REPORT TO THE CALGARY PLANNING COMMISSION

DEVELOPMENT PERMIT	ITEM NO: 01	
	CPC DATE:	2011 October 27
	DP NO:	DP2011-2330

BELTLINE
(Ward 8 - Alderman Mar)

PROPOSAL:
New: Multi-Residential Development (171 Units), Live Work Units (7 Units)

Gibbs Gage
 ARCHITECTS
 200, 27th Avenue S.E. Calgary, Alberta T2C 2S2
 Tel: 403.270.0000 Fax: 403.270.0077
DP1.2

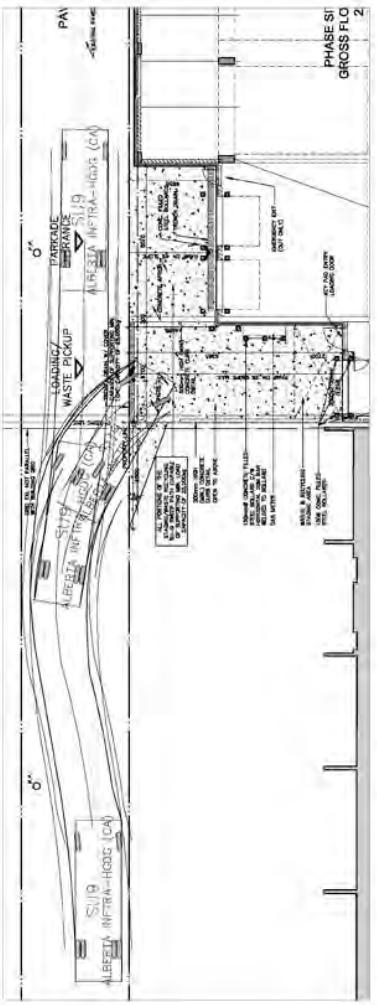
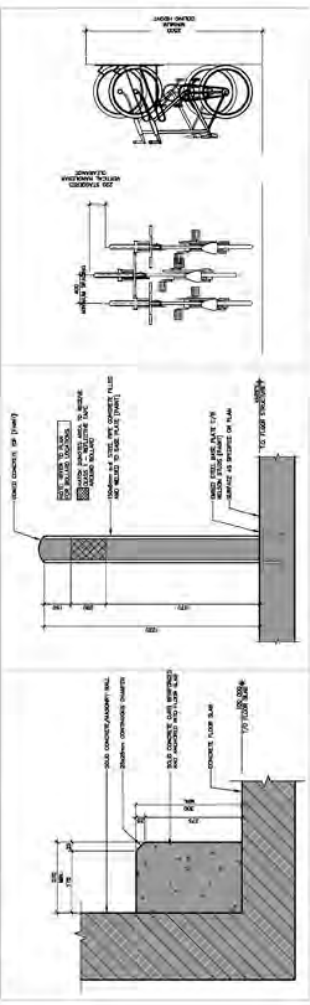
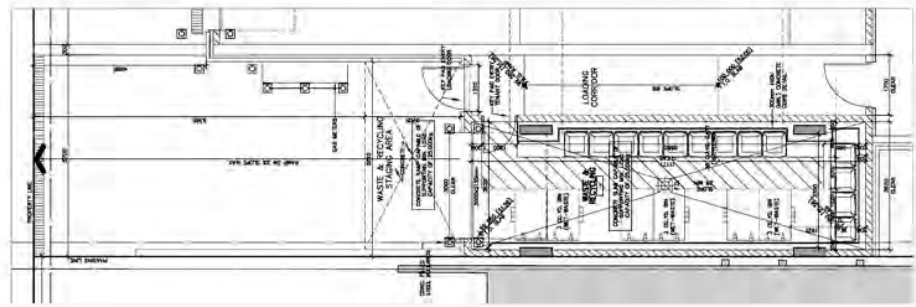
- Provide design details and dimensions (manufacturer specifications) for all Class 2 (short-stay) bicycle parking stalls and Class 1 (secure) bicycle parking stalls on the development plans.

- Revise the design of Class 2 bike parking (short-stay) stalls to:
 - allow a bicycle frame and both wheels to be secured.
 - support the bicycle frame and both wheels.

DPE100. 10/27/11 (M) 10/27/11 (M) 10/27/11 (M) 10/27/11 (M) 10/27/11 (M) 10/27/11 (M) 10/27/11 (M) 10/27/11 (M) 10/27/11 (M) 10/27/11 (M)

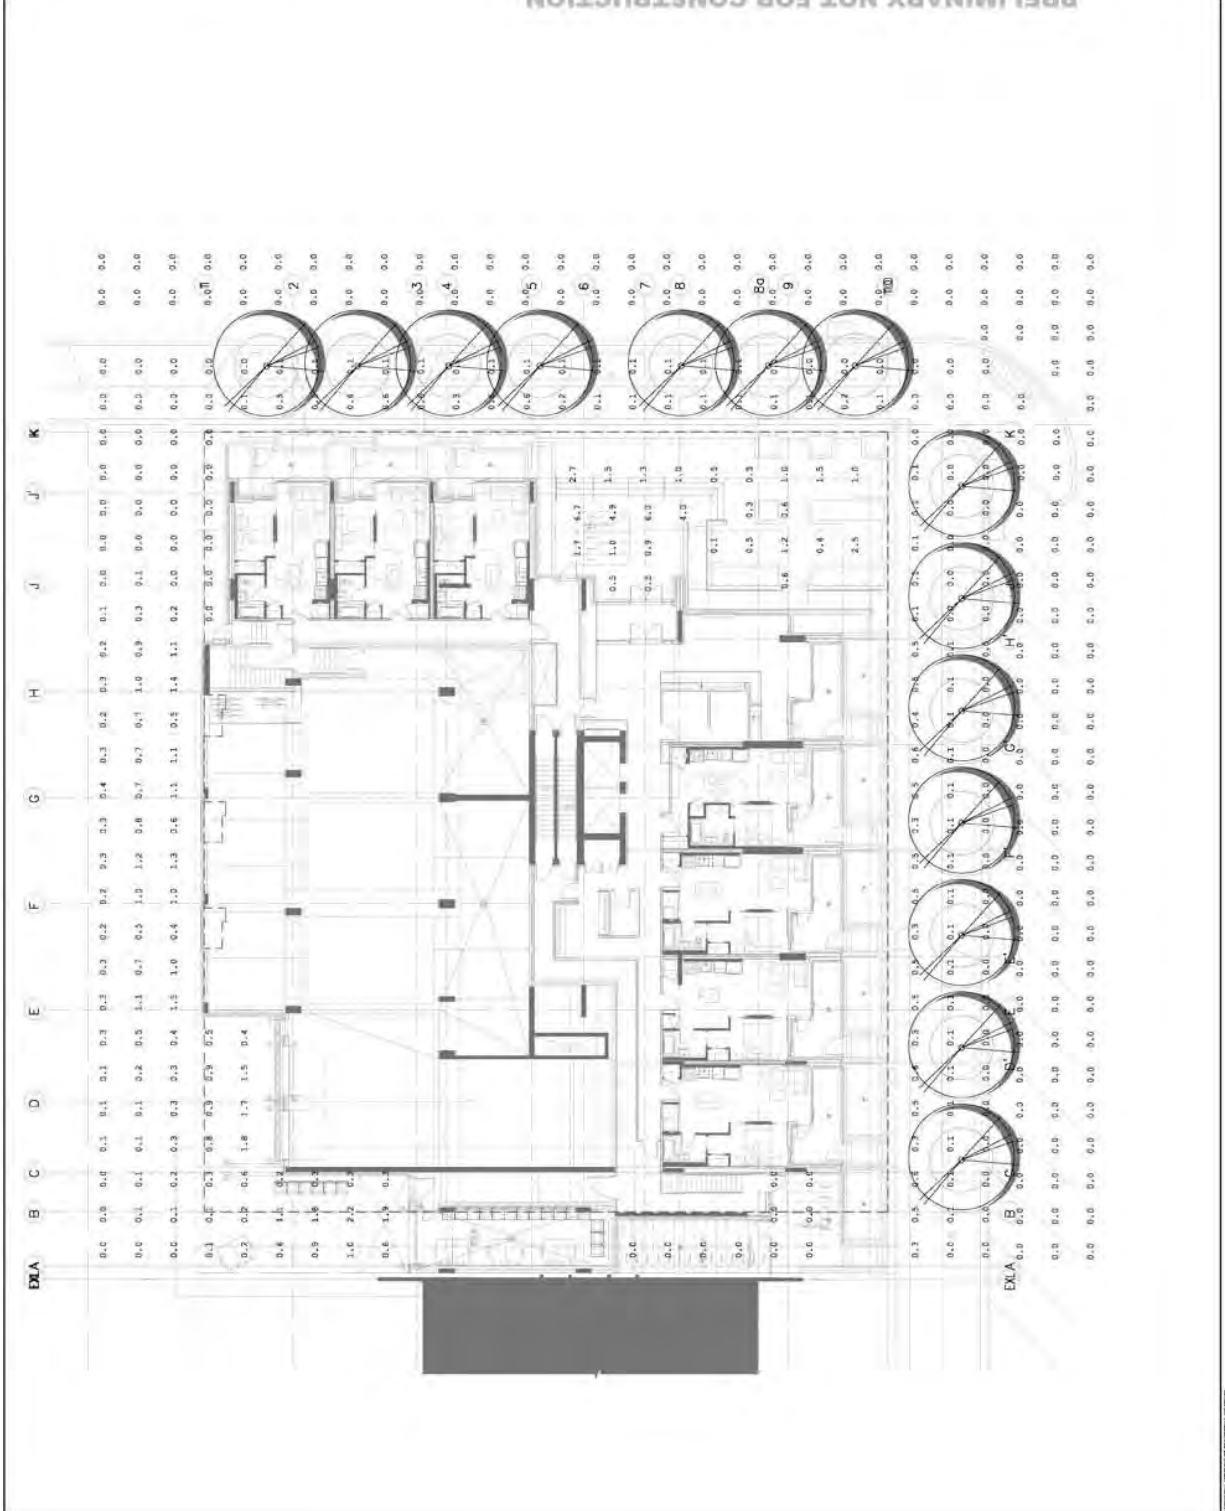
12. Remove the western-most proposed tree along 16 Avenue SW on DPE-100 in order to match with the number and location of the proposed street trees on DP1.1 and DPL.1 drawings.
